MEETING: REGULAR MEETING OF THE PLAN COMMISSION
DATE & TIME: Monday, June 9, 2025 at 6:30 PM
LOCATION: Germantown Village Hall Board Room
N112 W17001 Mequon Road

- V. **UNFINISHED BUSINESS:**
 - A. Parish Survey & Engineering, Agent for Matt Seban and TLC Acres, Property Owner W210N10738 Appleton Avenue. Site Plan Review for a 5,200 sqft building and a Conditional Use Permit (CUP) Application to allow grading & filling within a 25' wetland and 75' navigable waterway setback. (ACTION; Continued from April 28)

- VI. **NEW BUSINESS:**
 - A. Ken Frank, Agent for Home Path Financial, LP, and Mohrhussen Family Farm, LLC, Property Owner. Rezoning application to create the "Sutton Farm" Planned Development District (PDD) and Rezone 88.3 acres from the A-1: Agricultural District into the Sutton Farm PDD; and a Preliminary Subdivision Plat for an 88.3-acre residential neighborhood comprised of 171 single-family units and 102 multi-family units located at the northeast corner of Lannon Road (CTH Y) @ County Line Road (CTH Q) in the Lannon Gateway Neighborhood. (PUBLIC HEARING & ACTION)

SHEET NO:
C1.01

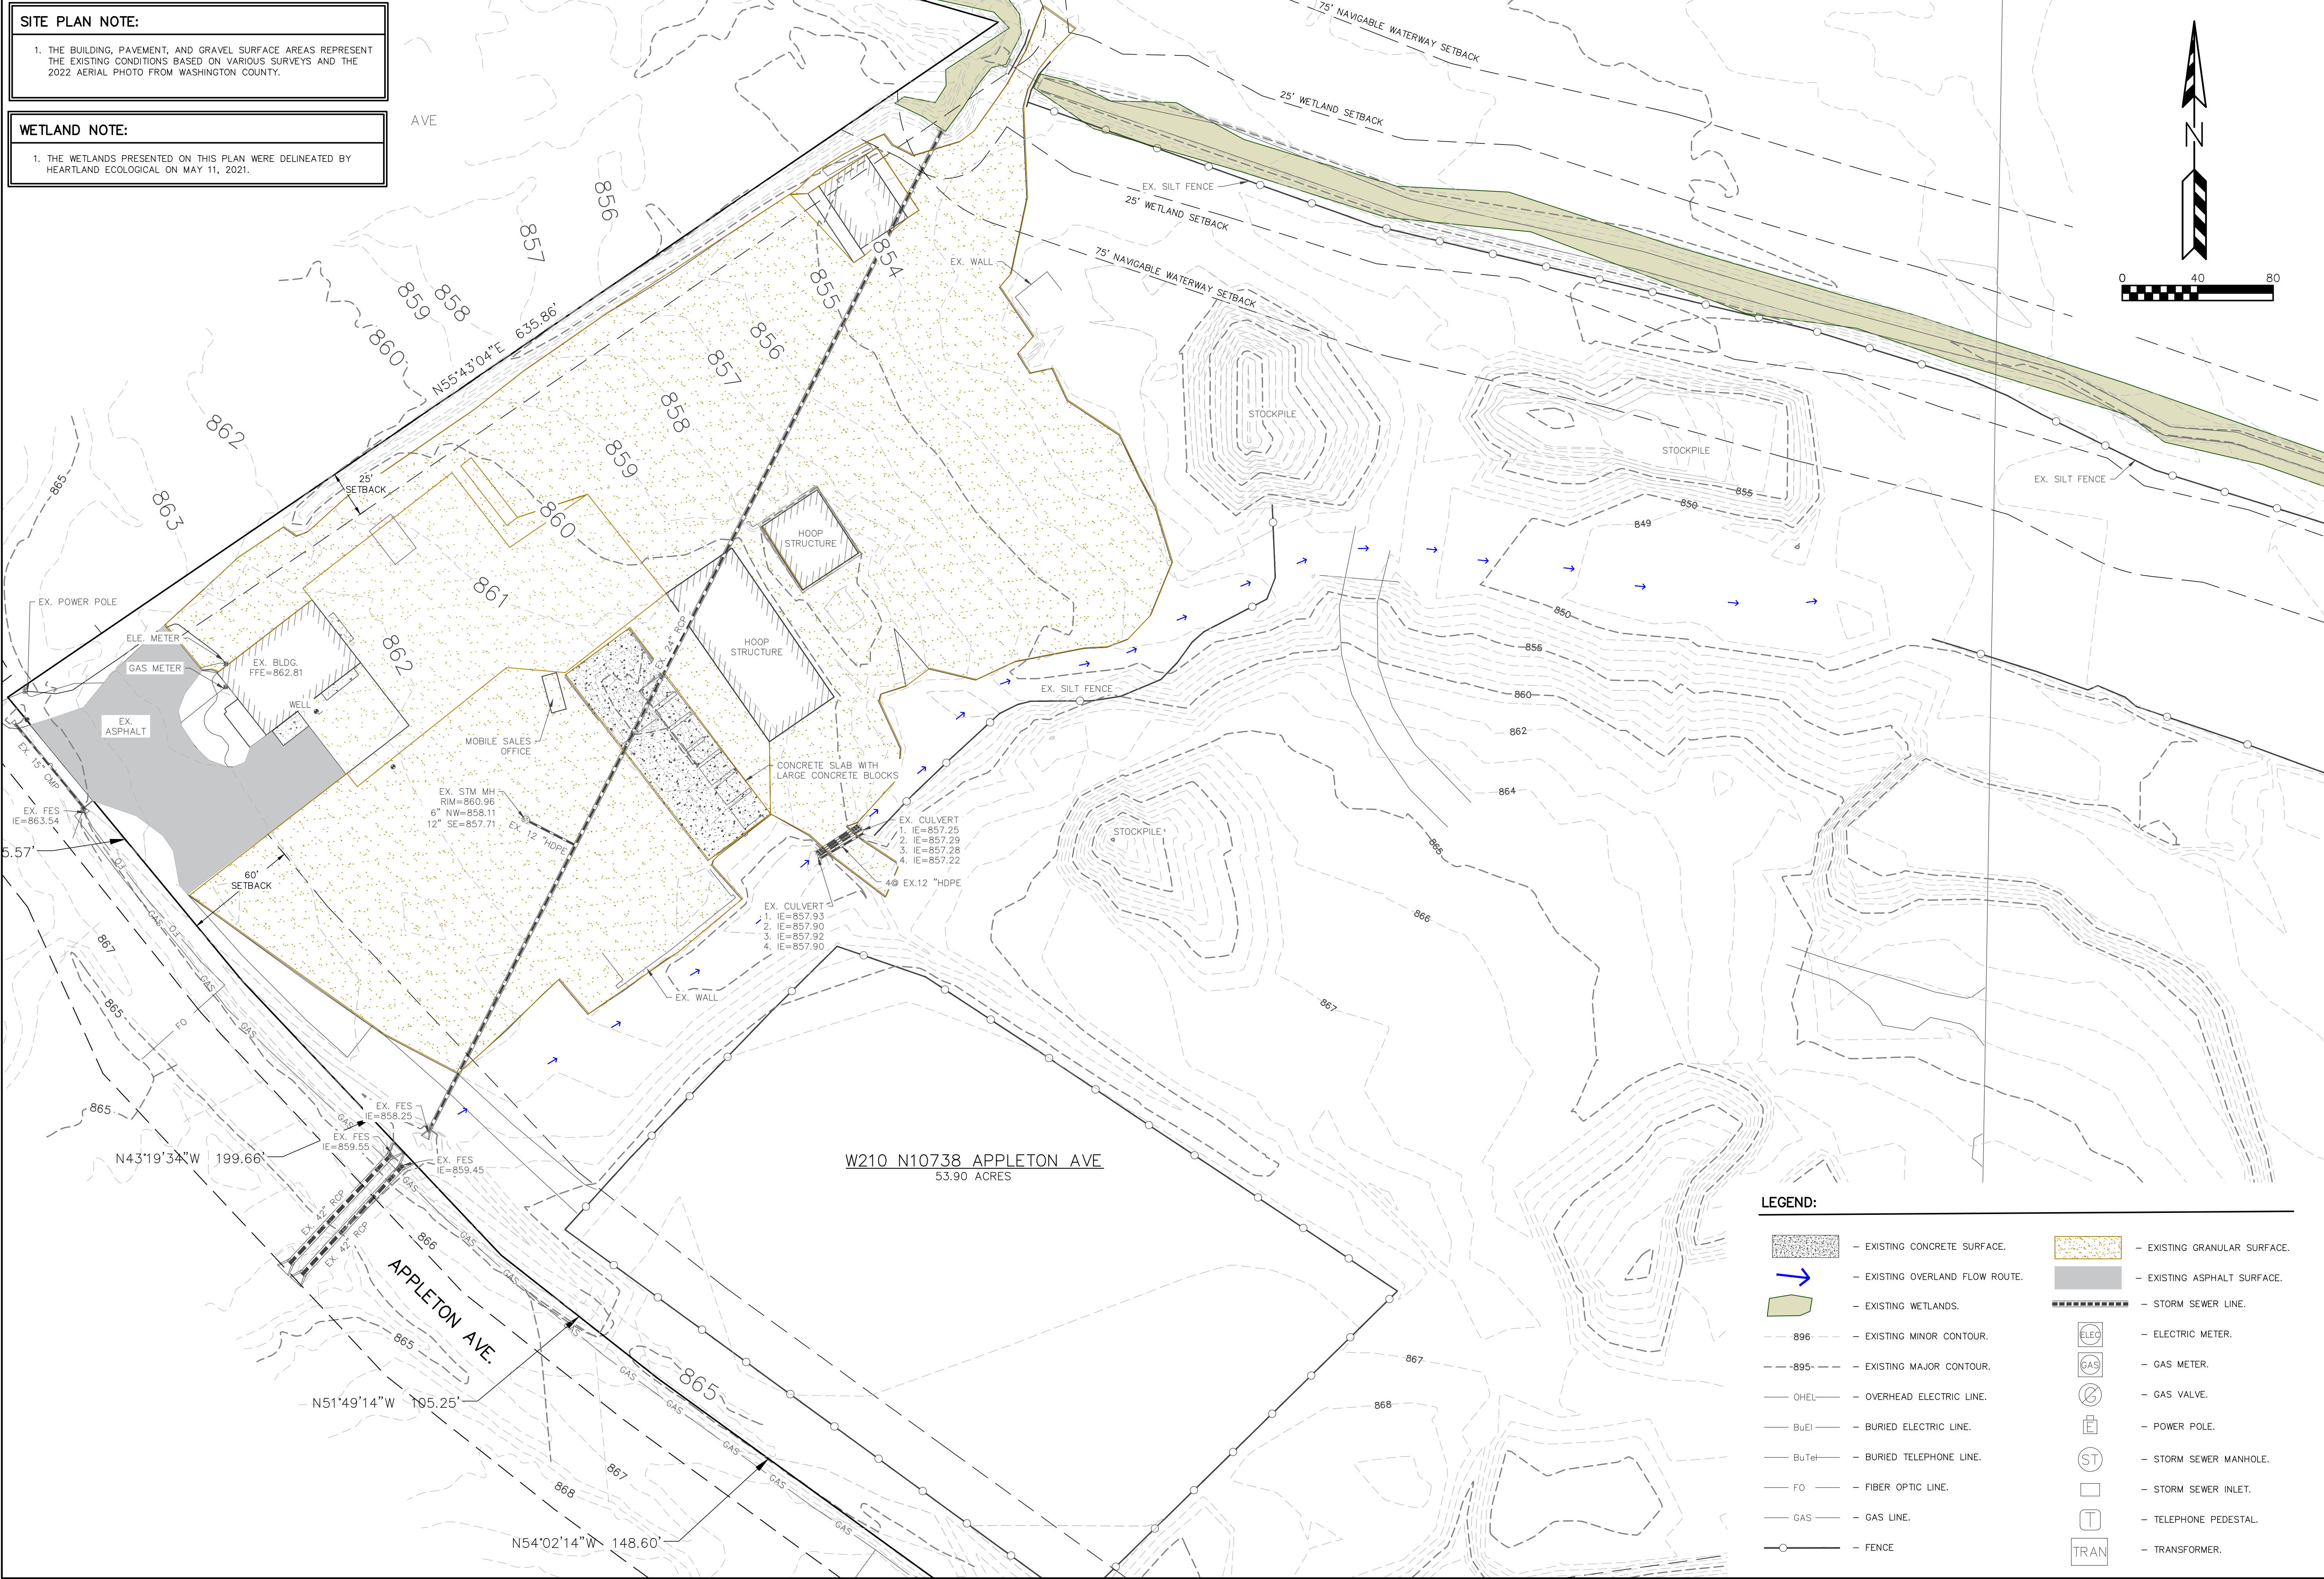
1. Applicant to follow the Development Handbook. See attached.
2. Missing cover page. Add cover page.
3. Sheet C1.01 - Missing benchmarks. Show reference datum.
4. Sheet C1.02 - Existing stockpiles. Are those to remain?
5. Sheet C1.03 - Storm Water Pond is shown at 850.5. That corresponds to the new floodplain elevation.
6. Sheet C1.04 - Show drainage path, (per 1.3.2.10 & 1.3.2.16) and slope at 1.5% minimum (per 4.1.5)
7. Sheet C1.05 - Proposed berm elevation of 853 around proposed storm water pond. No fill allowed in any future floodplain once maps adopted.
8. Sheet C1.05 - Elevations to match sheet C2.02
9. Sheet C2.01 - follow WDNR BMPs
10. Sheet C2.02 - Elevations to match sheet C1.05
